UNIVERSITY OF TEXAS AT AUSTIN  
NUCLEAR ENGINEERING TEACHING LABORATORY  
TRIGA RESEARCH REACTOR  
LICENSE NO. R-129  
DOCKET NO. 50-602

EMERGENCY PLAN REVISION NO. 4  
APRIL 25, 2019

## **ATT 1: SUMMARY OF CHANGES TO THE EMERGENCY PLAN UNDER REVISION 4**

Figure 4-1, NETL Operating Organization

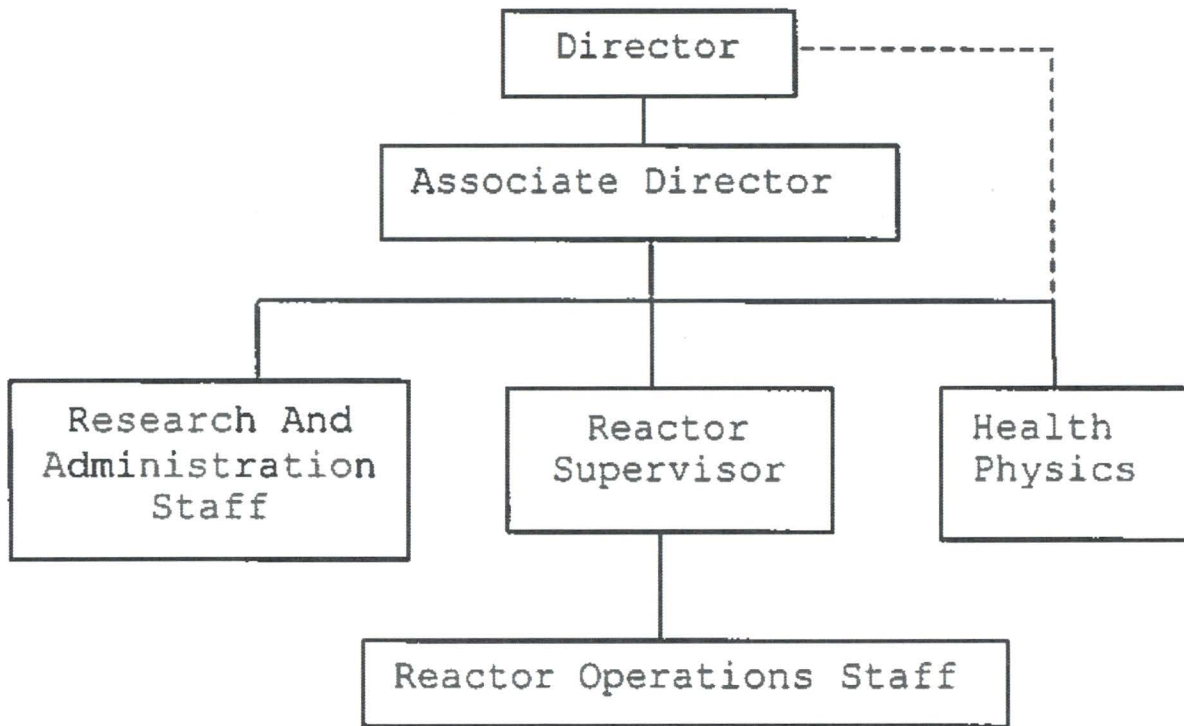
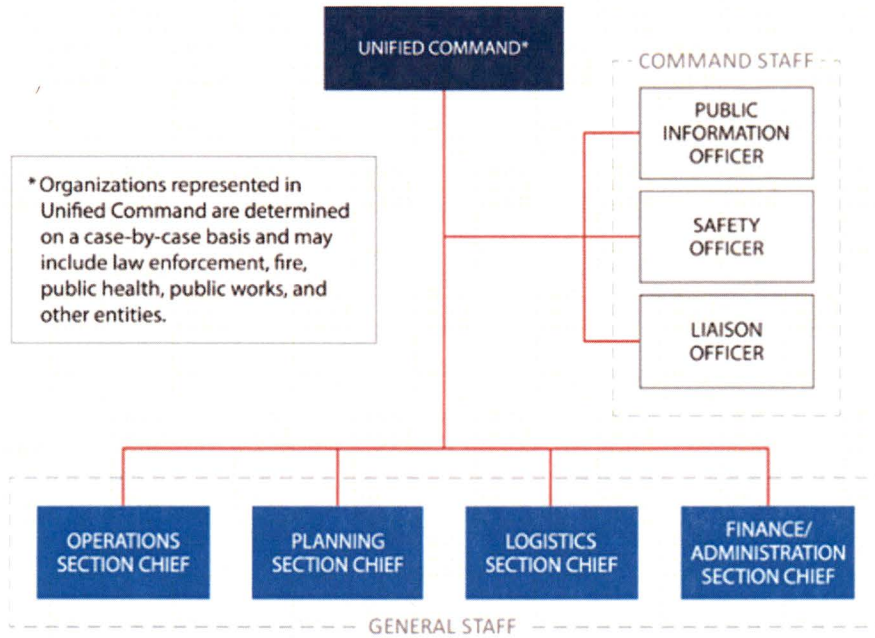
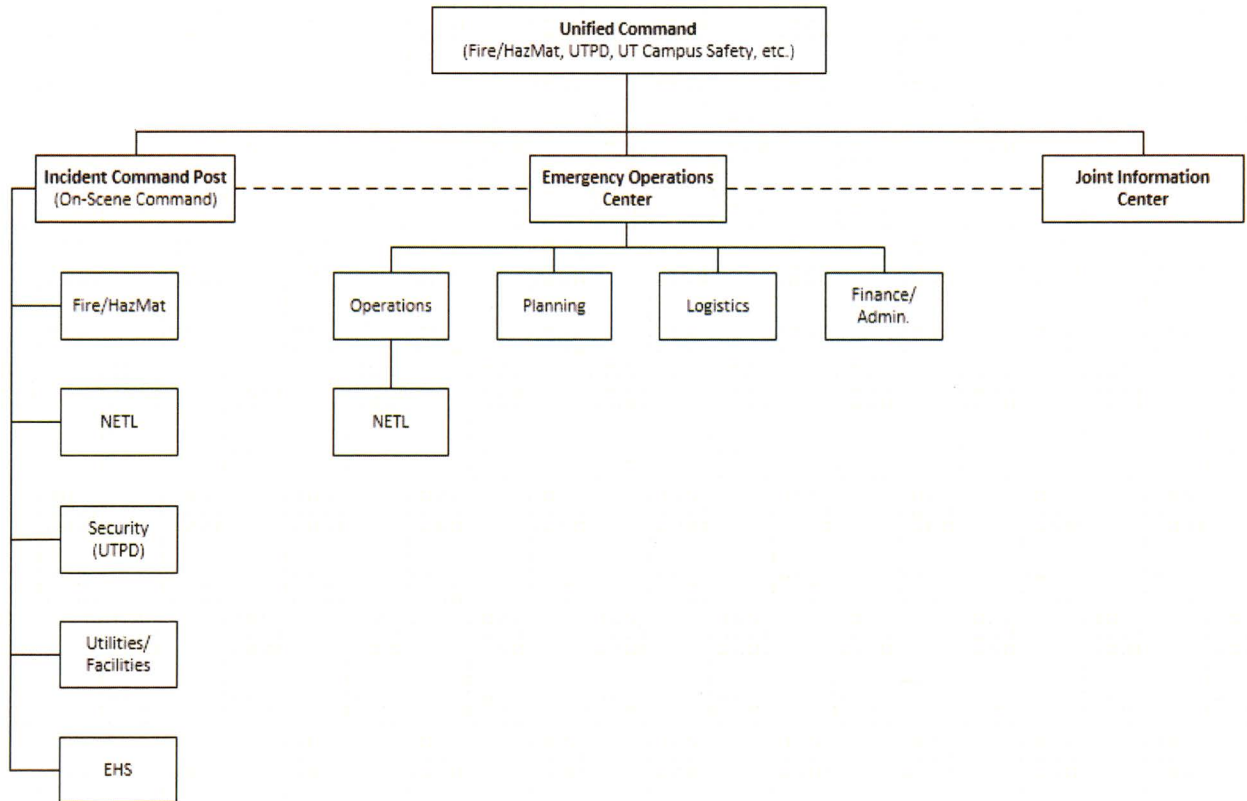
EP, Section 2, 1<sup>st</sup> paragraph, first sentence:

The emergency organization for The University of Texas TRIGA reactor facility consists of three functional groups. A block diagram presentation of the organization is in Figure 4 of the Appendix.

The referenced diagram did not reflect current practice, which follows the National Incident Management System, and was revised to:

The normal operating organization is structured as provided in Fig. 4-1. The emergency organization for The University of Texas TRIGA reactor facility follows the National Incident Management System (NIMS) model. NIMS is design to flexible so that it may be implemented as needed. A block diagram presentation of the normal and emergency organization is provided in Fig. 4-3, with a sample implementation in Fig. 4-4. A relatively small incident at NETL may consist of the NETL emergency director as the only person in Unified Command with NETL staff acting as operations personnel and no other sections being staffed. A larger incident involving outside responders would likely result in representatives from various responding agencies in Unified Command with the NETL emergency director and multiple divisions of the operations section. The Public Information Officer and Safety Officer positions would likely be staffed as well. Other sections may or may not be staffed depending on complexity and duration of the incident.
